ARCHITECT'S ADDENDUM

Addendum Number: 03

RE: EAHS 2026 Secured Entrance

Subject: Addendum 03 to the Construction Documents for the East Aurora High School 2026 Secured Entrance Project.

INTERIOR
ELEVATIONS,
STOREFRONT
ELEVATIONS, WALL
TYPES, & DETAILS

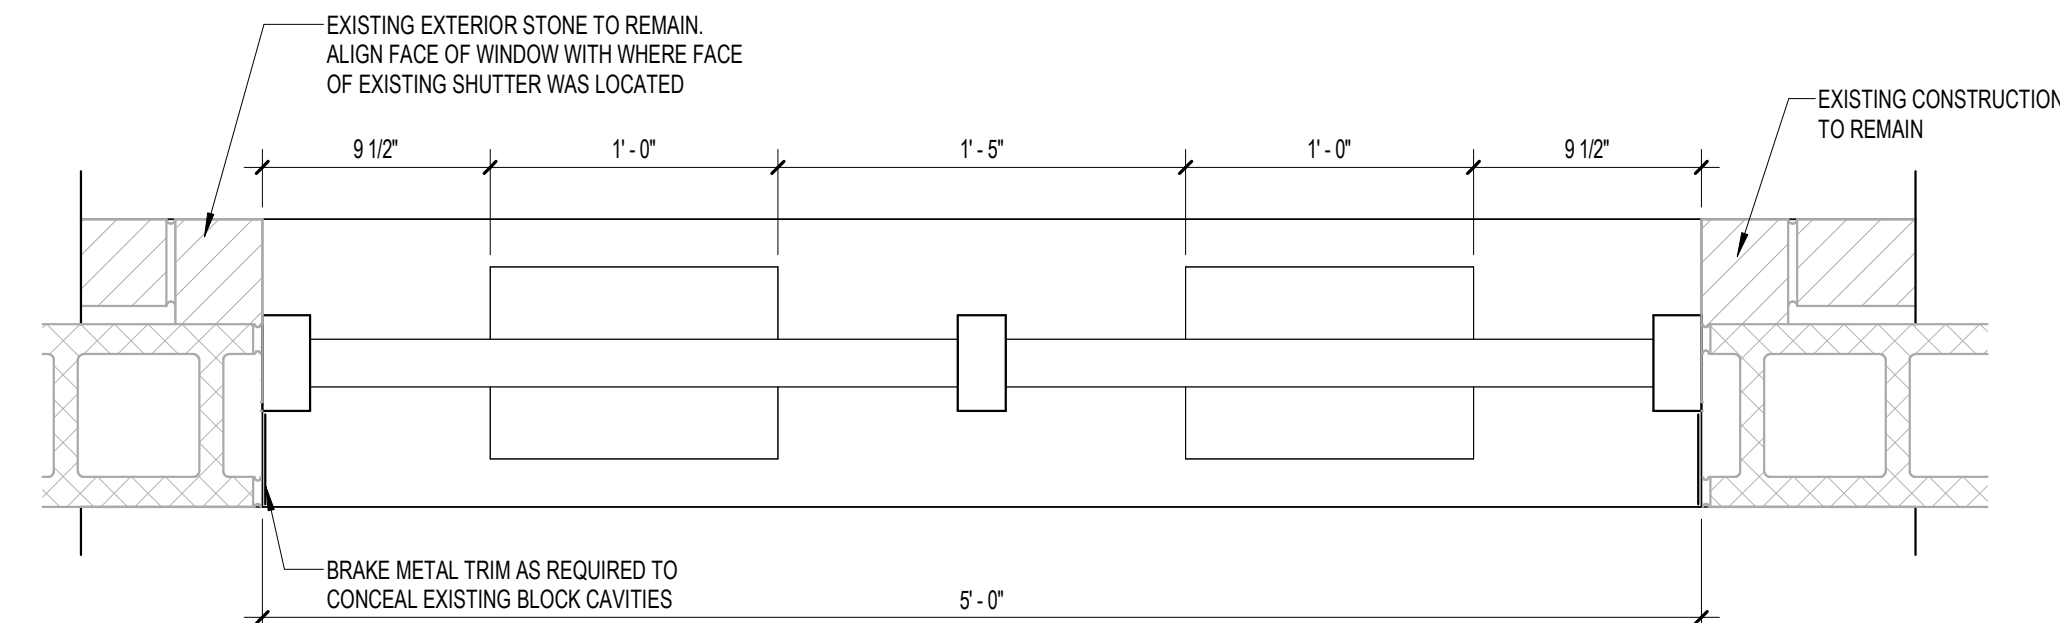
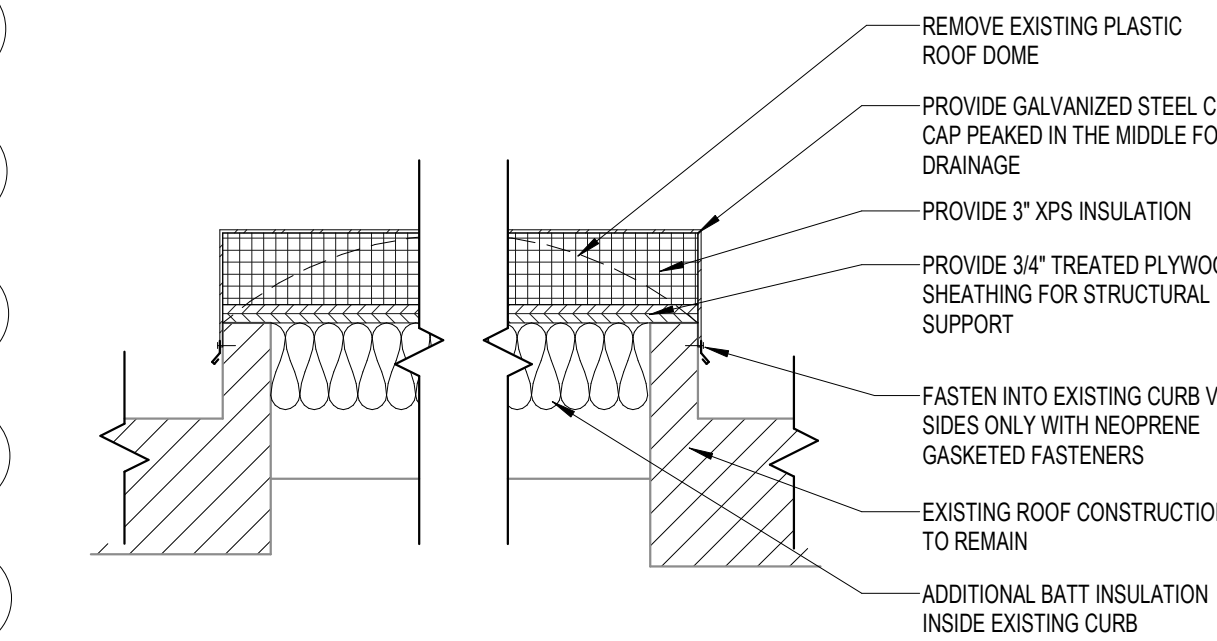
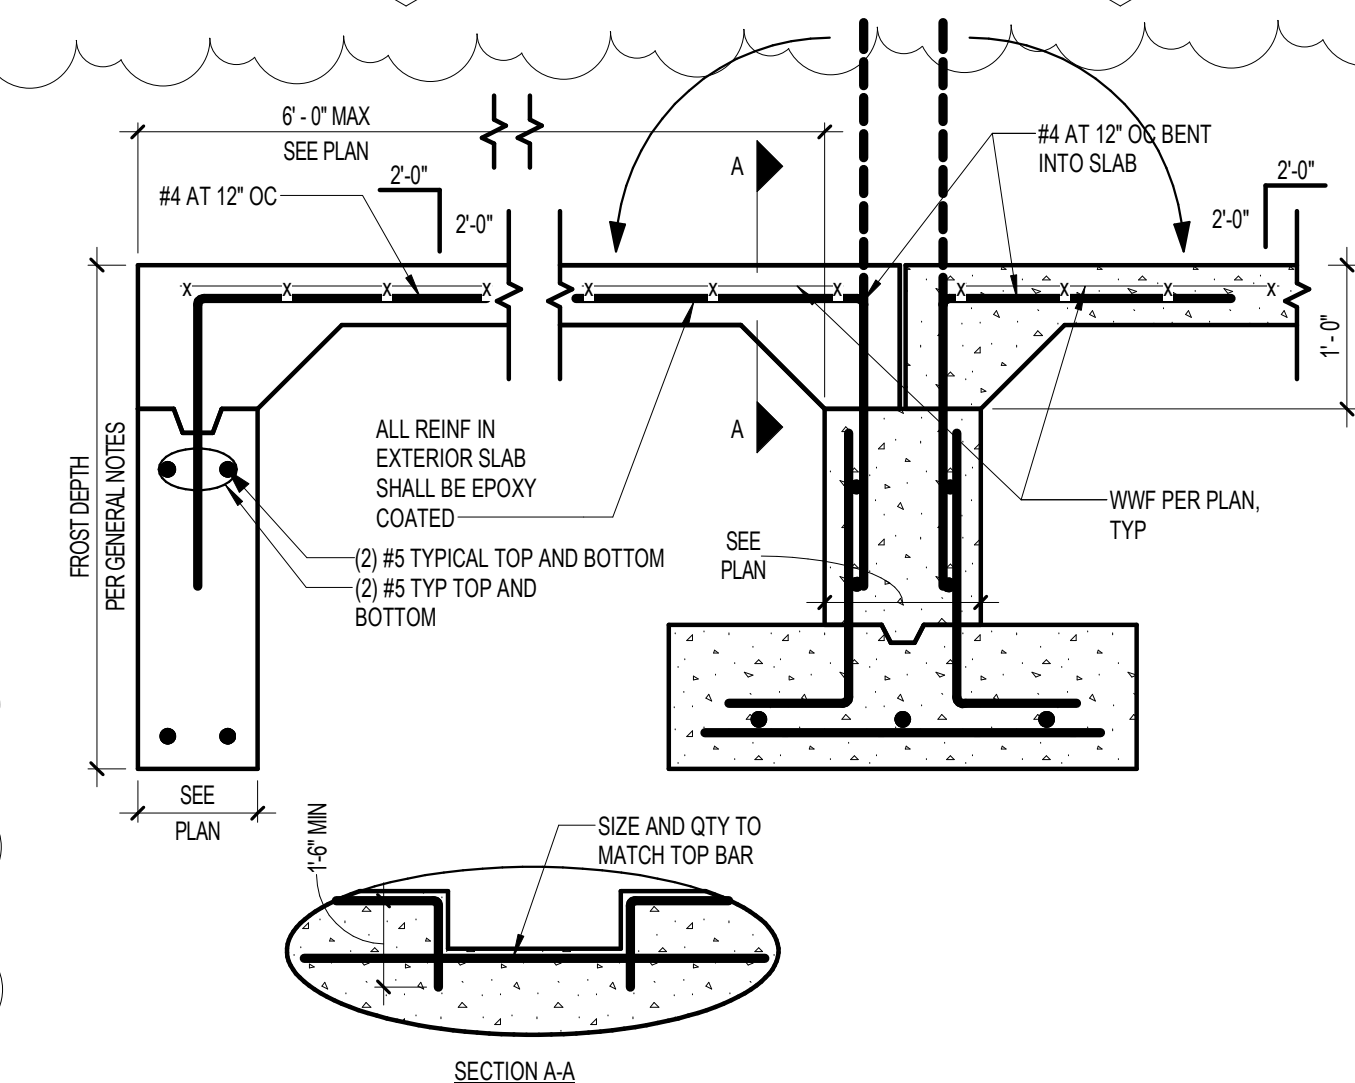
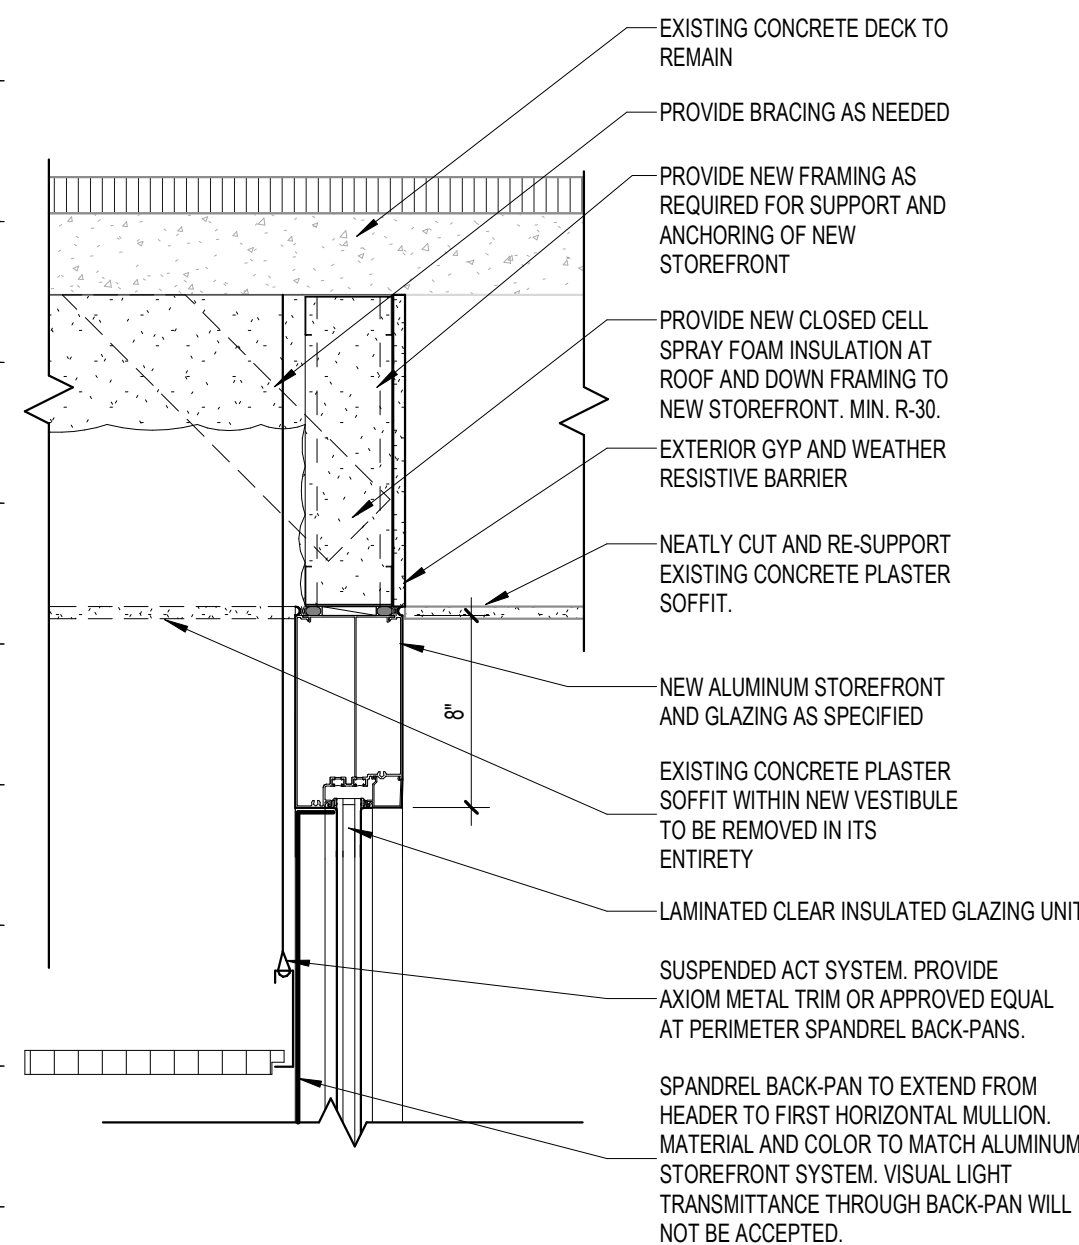
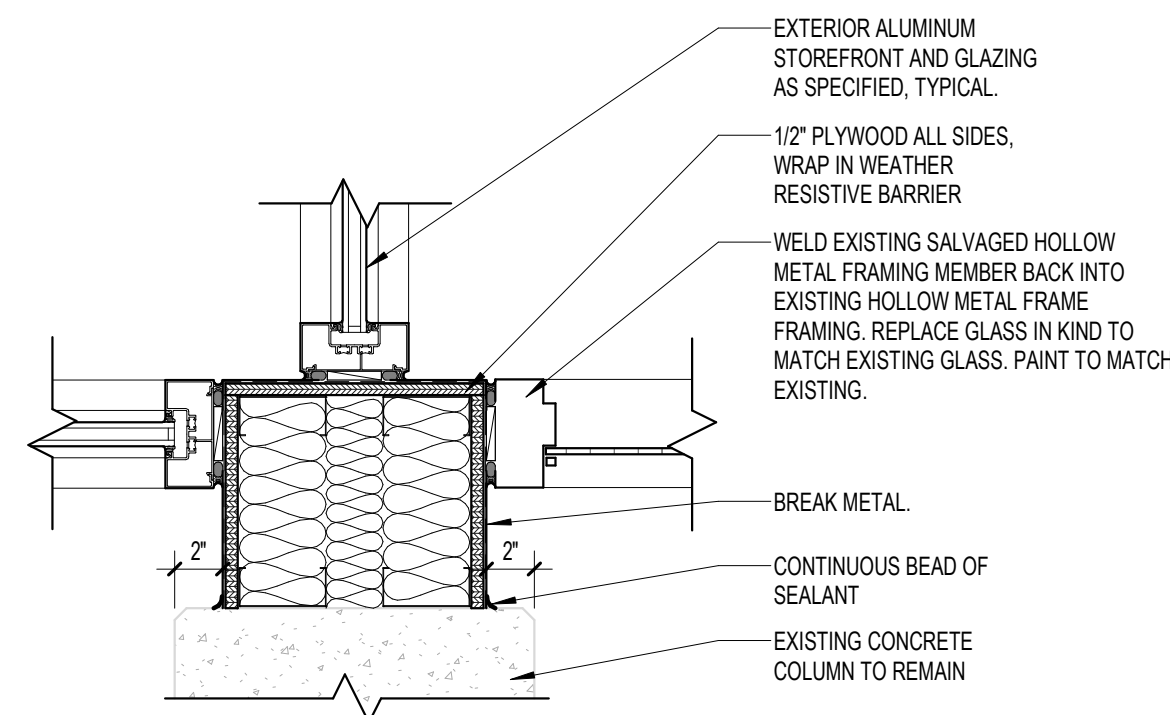
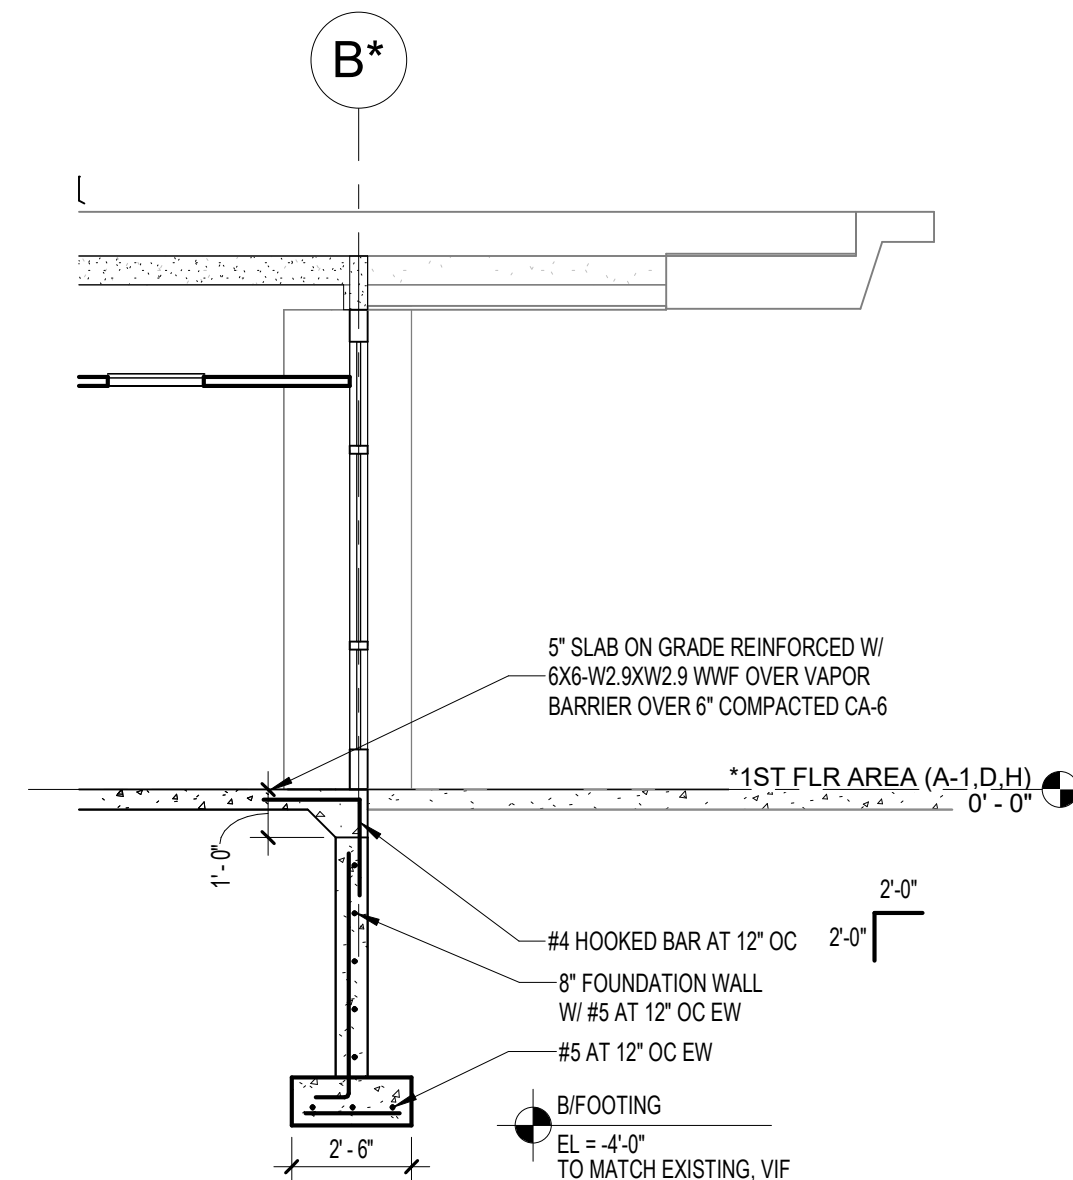
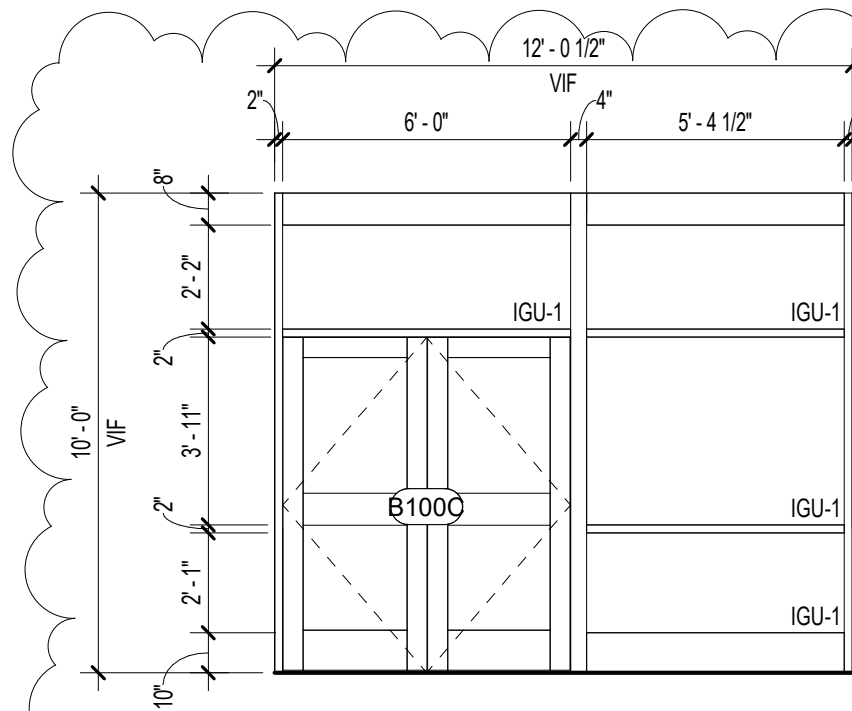
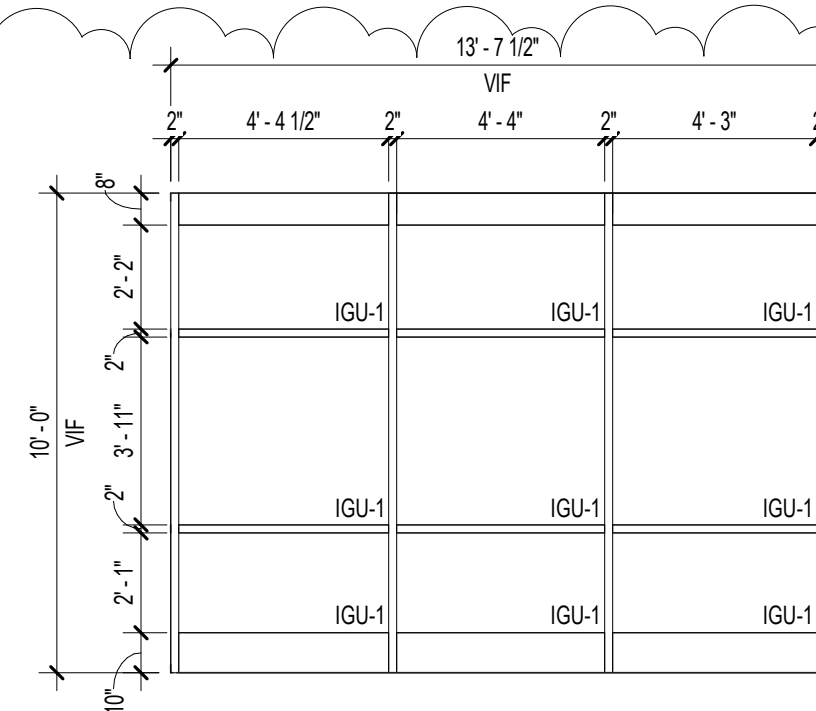
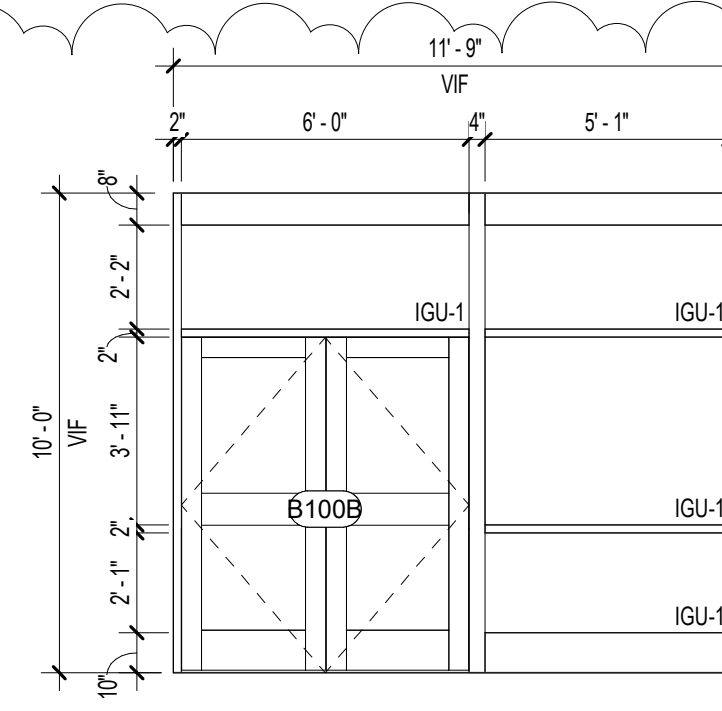
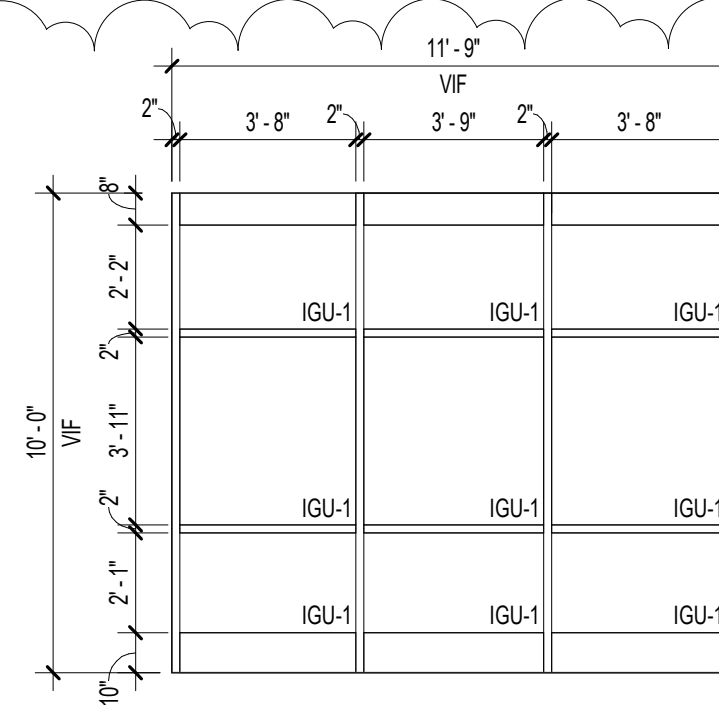
- 1) Sheet A1.00 – Partial First Floor Plan – Area B
 - **REVISED** Existing Conditions Photograph, Elevations, and New Work Plan. Refer to clouded regions on the attached drawing sheet.
- 2) Sheet A2.00 – Interior Elevations, Storefront Elevations, Wall Types, & Details
 - **REVISED** Glazing Notes and Legend, Alternate Descriptions, Storefront Elevations, and Detail 5 – Typical Header Detail – Main Entrance. Refer to clouded regions on the attached drawing sheet.

LAMINATED CLEAR INSULATED GLAZING UNIT. REFER TO SPECIFICATIONS. LAMINATED GLAZING TO BE BASE BID.

NON-LAMINATED INSULATED CLEAR GLAZING UNIT.
REFER TO SPECIFICATIONS. REFER TO ALTERNATES.

ALTERNATE #01 - FURNISH AND INSTALL NON-LAMINATED INSULATED GLAZING IGU-3 IN LIEU OF LAMINATED GLAZING IGU-1. FURNISH AND INSTALL 3M SAFETY SECURITY WINDOW FILM OR EQUAL.

ALTERNATE #02 - FURNISH AND INSTALL NEW STOREFRONT (BEYOND VESTIBULE, FROM GRIDLINE 30 EASTWARD, ROUGHLY 53 FEET) AS SHOWN ON SHEET A1.00.

ALTERNATE #02A - FURNISH AND INSTALL NON-LAMINATED INSULATED GLAZING IGU-3 IN LIEU OF LAMINATED GLAZING IGU-1. FURNISH AND INSTALL 3M SAFETY SECURITY WINDOW FILM OR EQUAL FOR ALTERNATE 2 STOREFRONT LOCATIONS.
